1 SITE PLAN
SCALE: 1" = 10'-0"

DELRAY DERMATOLOGY
802 SE 5th Avenue
DELRAY BEACH, FL

Site Plan Review Set
File No. 2024-254

(A101

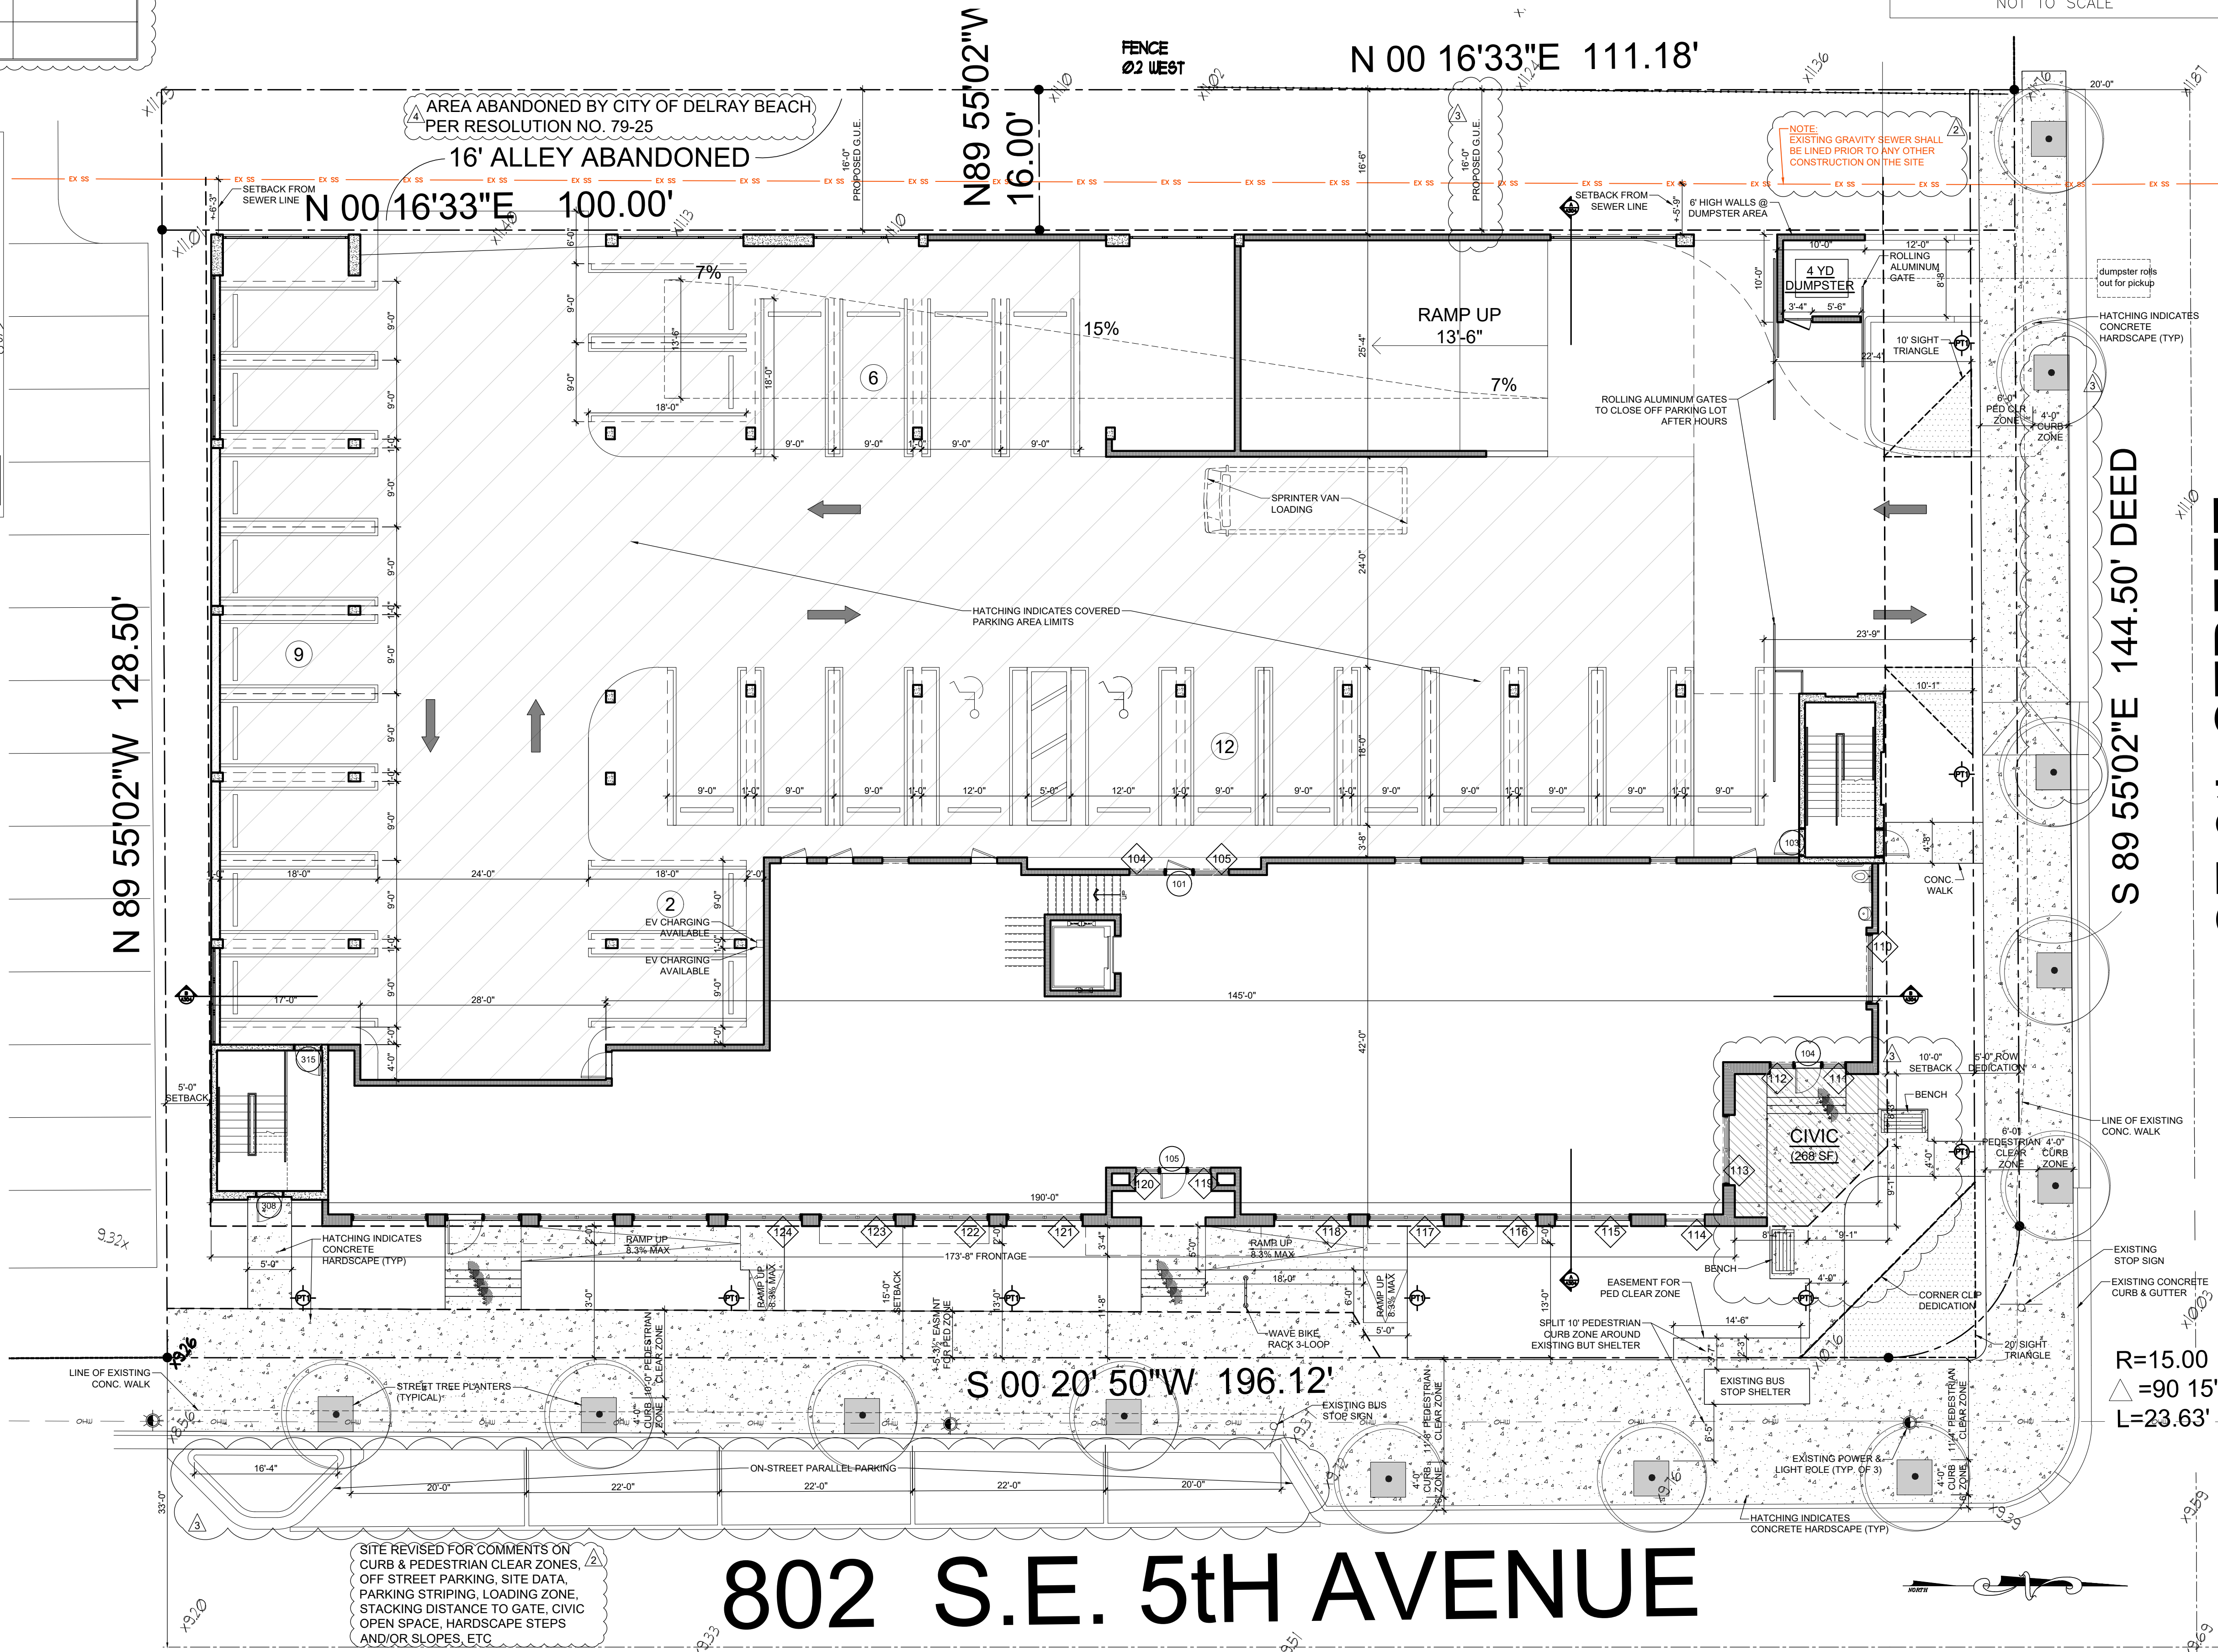
SITE REVISED FOR COMMENTS ON CURB & PEDESTRIAN CLEAR ZONES, OFF STREET PARKING, SITE DATA, PARKING STRIPING, LOADING ZONE, STACKING DISTANCE TO GATE, CIVIC OPEN SPACE, HARDSCAPE STEPS AND/OR SLOPES, ETC
